Access Compliance Report

Public Rights-of-Way

(Curb Ramps)

Intersection ID: 49137	Main Street: LESTER_HILL_CT	Cross Street: POPE_FARM_RD	Location: NW
ADA ID: C905DD972FDD	Ramp Type: PerpDiag	Initial Pass/Fail: Pass	Overall Compliance: No
		Severity Score: 5.25

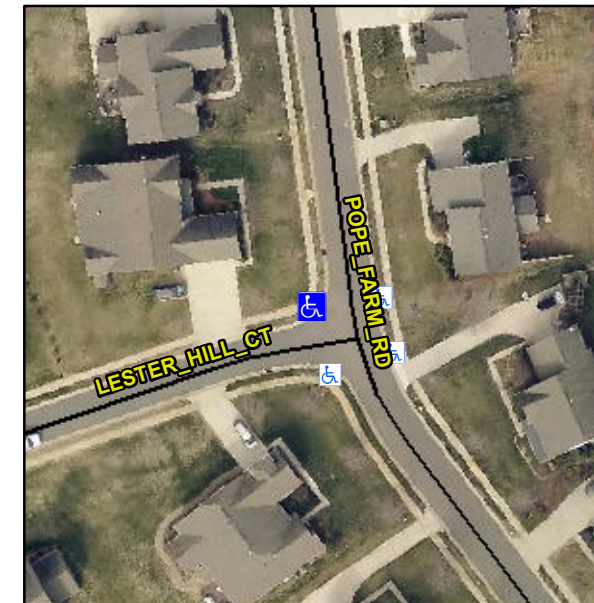
Not Found, R304.5.3, R304.2.1, R305.2, R304.5.4

Compliance	Description	Data	Compliance	Description	Data
N/A	Ramp Length (in)	48.0	Yes	Ramp Slope (%)	7.0
Yes	Ramp Width (in)	48.0	No	Ramp XSlope (%)	2.2
N/A	Flare Type LT	Sloped	N/A	Flare Type RT	N/A
N/A	Flare Slope LT (%)	8.5	Yes	Flare Slope RT (%)	2.6
N/A	Flare Traversable LT?	Yes	N/A	Flare Traversable RT?	Yes
No	Landing Length (in)	47.0	Yes	DWS Provided?	Yes
Yes	Landing Width (in)	48.0	Yes	DWS Contrast?	Yes
Yes	Landing Slope (%)	1.5	Yes	DWS Length (in)	24.5
No	Landing X Slope (%)	2.5	Yes	DWS Full Width?	Yes
N/A	Landing Curb? (Y/N)	No	No	DWS Offset (in)	8.0
N/A	Shared Landing?	No			
Yes	Gutter Ponding?	No	No	Gutter Slope (%)	6.3
Yes	Gutter Lip Ht (in)	0.0	Yes	Gutter X Slope (%)	1.7
N/A	Painted X Walk1?	No	N/A	Painted X Walk2?	No
	X Walk 1 Direction	To S		X Walk 2 Direction	To E
N/A	X Walk 1 Width (in)	N/A	N/A	X Walk 2 Width (in)	N/A
	X Walk 1 Slope (%)	1.6		X Walk 2 Slope (%)	0.9
	X Walk 1 X Slope (%)	1.8		X Walk 2 X Slope (%)	0.0

Remove & Replace Curb Ramp With Two New Directional Ramps or Equivalent. Remove & Replace Gutter.
